Addendum No. 3
MOGUL BOOSTER PUMP STATION
PWP Bid No.: WA-2017-231
TMWA Capital Project No.: 13-0022
August 11, 2017

The following information, clarifications, changes and modifications are by reference incorporated into the bid documents for the above referenced project. Any work item or contract provision not changed or modified will remain in full force and effect.

MOGUL BOOSTER PUMP STATION
HVAC FLOOR PLAN

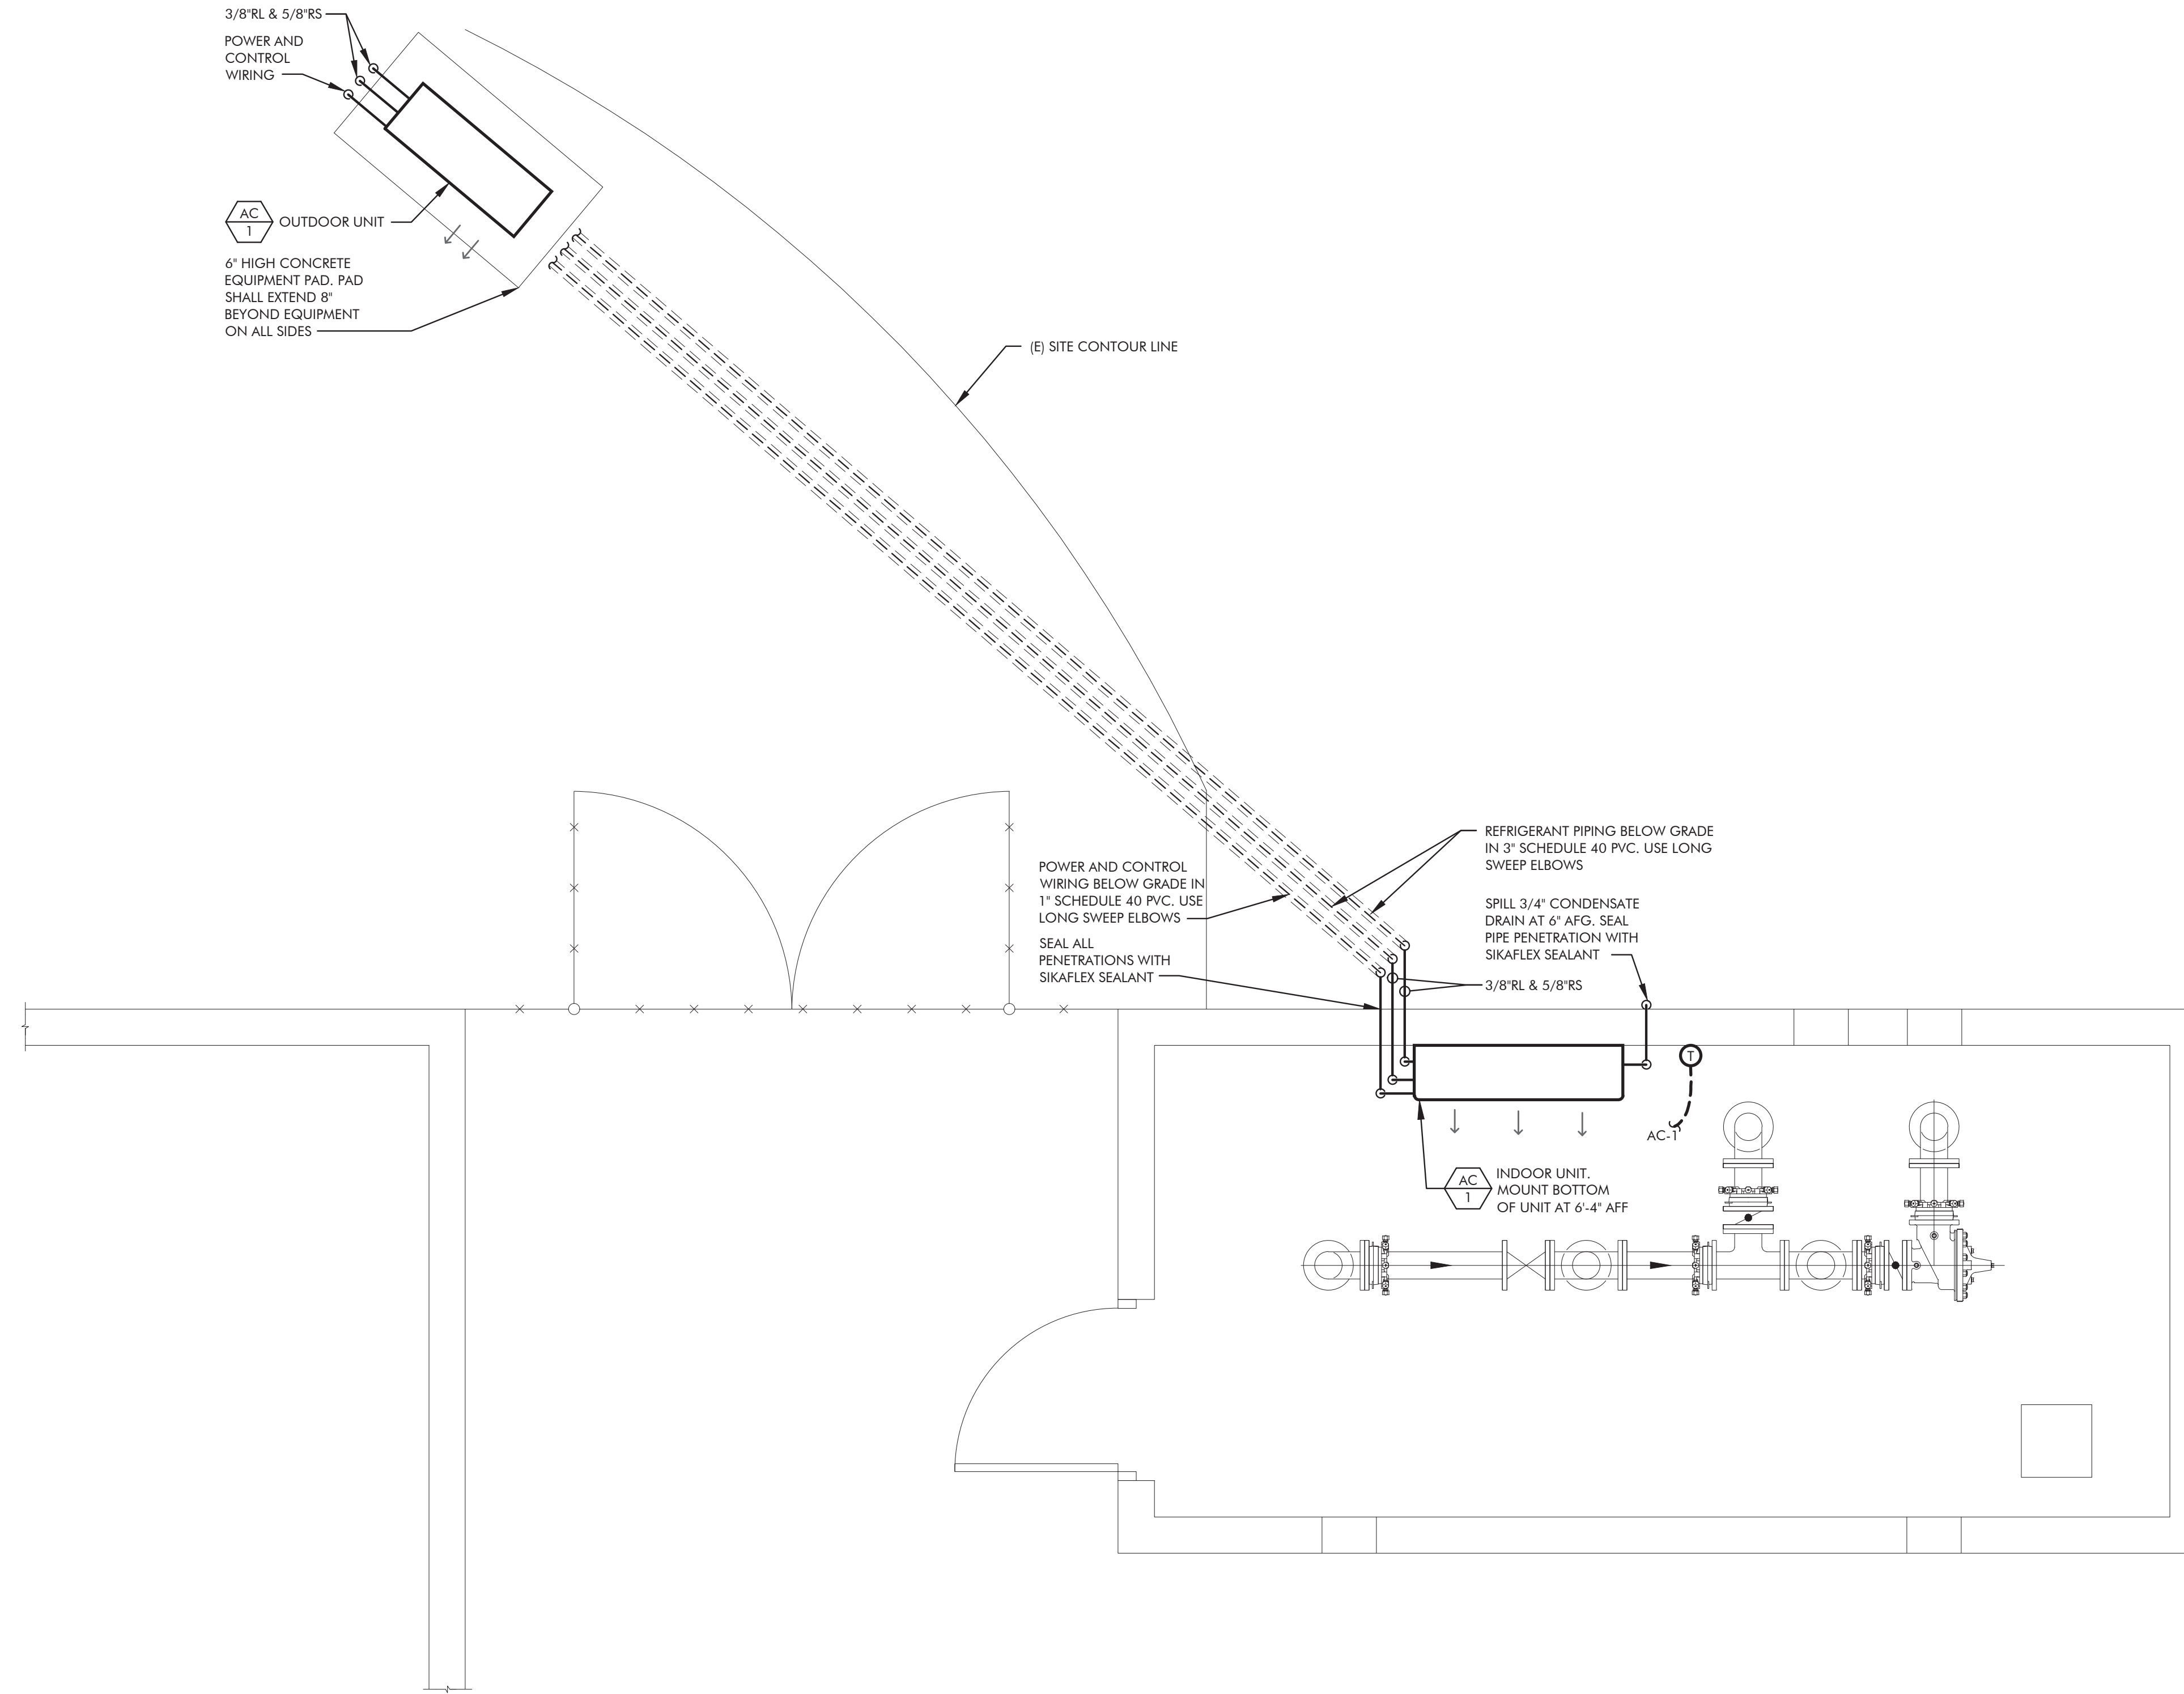
3. The Owner has added an air conditioning unit to the project. Please see enclosed HVAC sheets.
4. To accommodate the Air Conditioning unit, please make the following electrical modifications:

- a. See mechanical HVAC drawings for new pump house AC-1 unit's location and additional requirements.
 - b. Provide one 30A/2P circuit breaker at Panel LP-A for the new pump house AC unit.

- c. Provide one 30A/2P safety disconnect switch at outdoor AC-1 unit.
 - d. Provide new conduit P00009A from LP-A to outdoor AC-1 unit with 1"C-2#10,1#10G.

- e. Provide new conduit P00009B from outdoor AC-1 unit to indoor AC-1 unit with 1"C-2#10,1#10G.
 - f. Provide new conduit C00004 from outdoor AC-1 unit to indoor AC-1 unit with 1"C-6#14,1#14G.
